## THM 440-T4 MODULATOR AND MODULATOR VALVE CHANGE

Figure 1

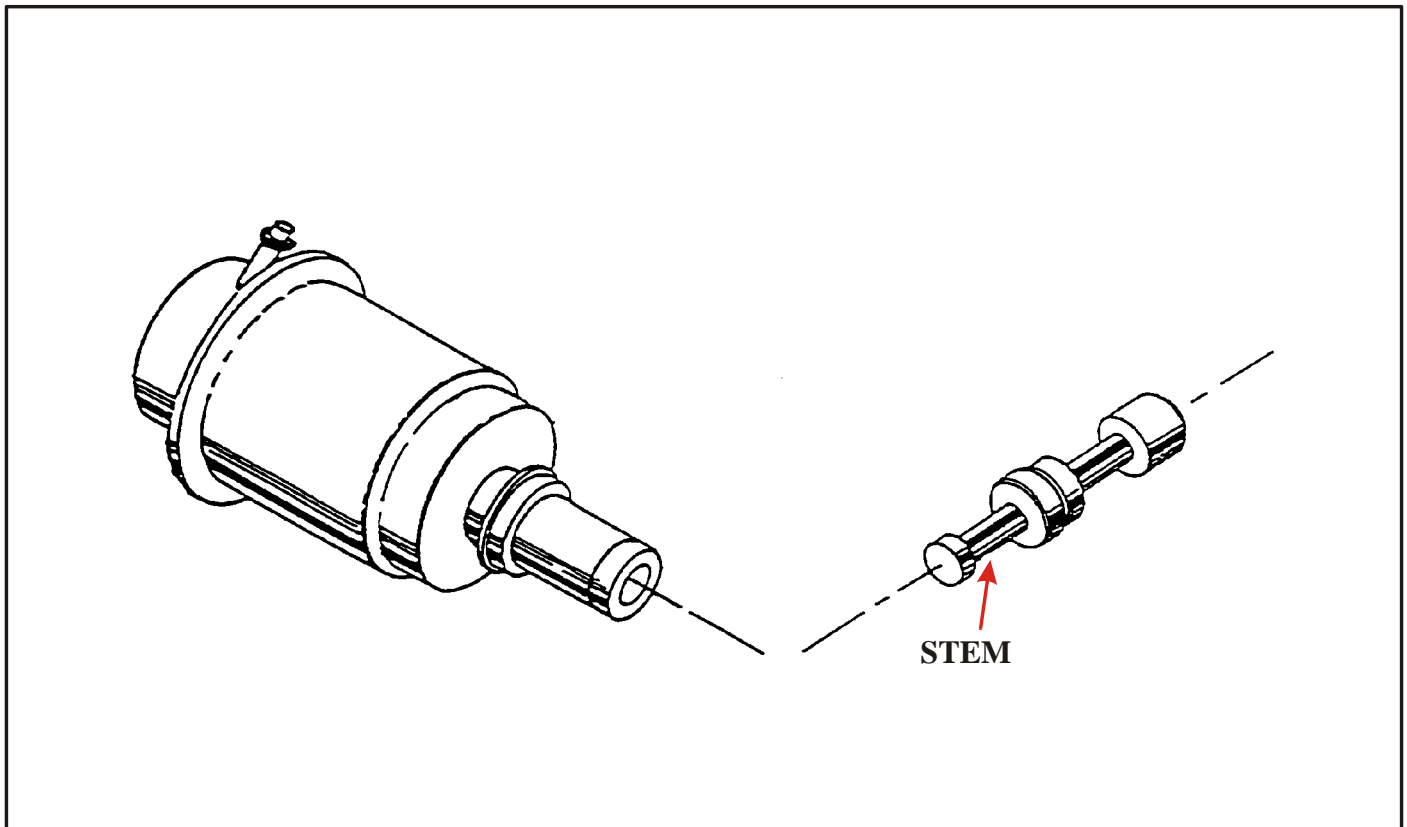
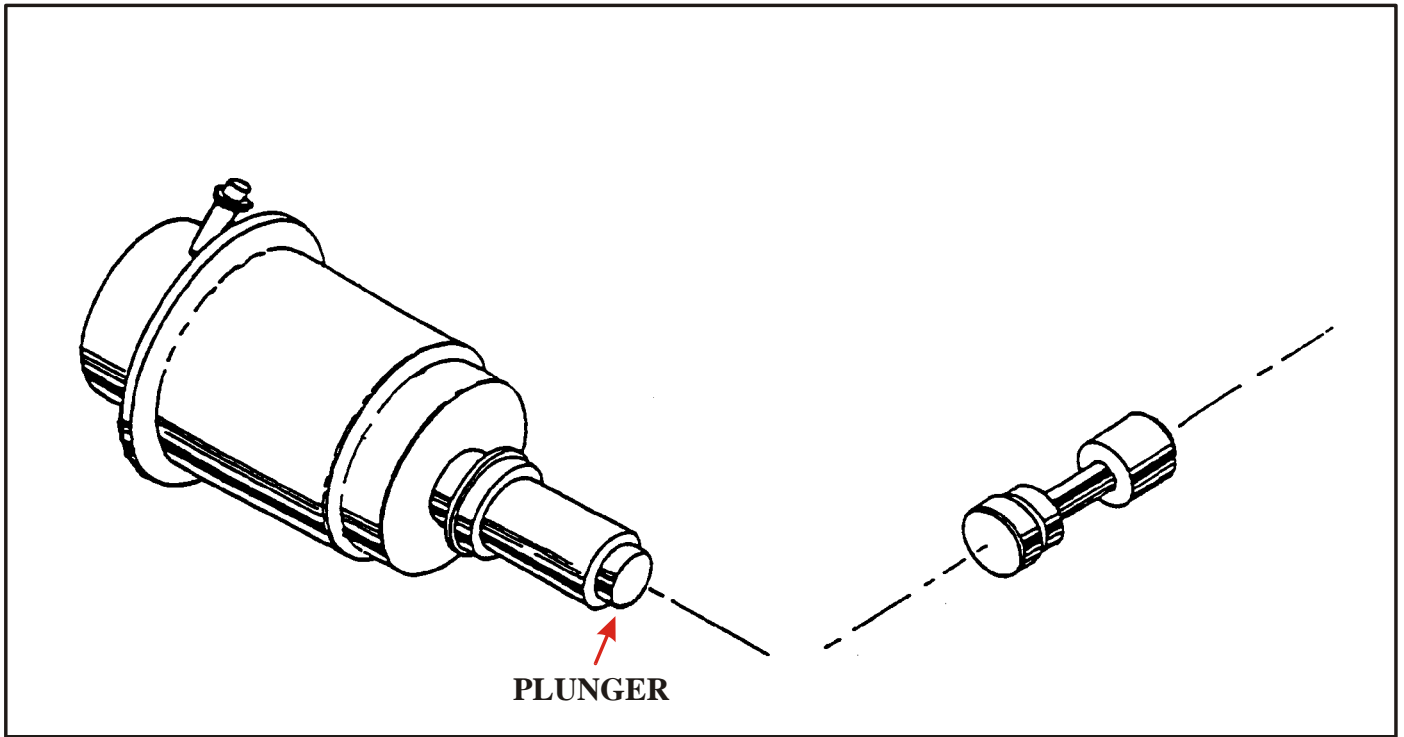
Some THM 440-T4 transaxle models may exhibit harsh upshifts when operated at high altitudes. This condition may be caused by excessive line pressure resulting from insufficient engine vacuum.

A new vacuum modulator assembly, and a new modulator valve have been released for service in a package (OEM Part No. 8646956). for the harsh upshift condition. The dimensions of the new vacuum modulator and the new modulator valve have changed drastically. If the previous style vacuum modulator was to be installed with the latest modulator valve, damage to the trans-axle could occur as a result of low line pressure.

Refer to Figure 1 for the Previous vacuum modulator and modulator valve, and Figure 2 for the latest vacuum modulator and modulator valve.
